Petition Number: Insert Zoning Petition #2021-012

General Location Identifier: Tax ID 10304112

Revision Log:	Date	Description	
	02-25-21	First Review (WB)

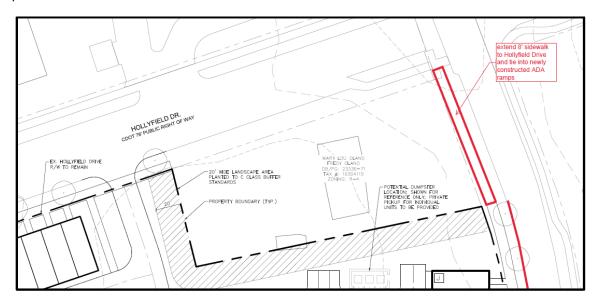
- 1. **Curbline:** The proposed zoning district has a setback measured from back of the existing or proposed future curbline.
  - a. **Wilora Lake Road:** The curb and gutter needs to be at 17.5 feet from the Wilora Lake Road centerline.

Label and dimension the back of curb and gutter from the road centerline.
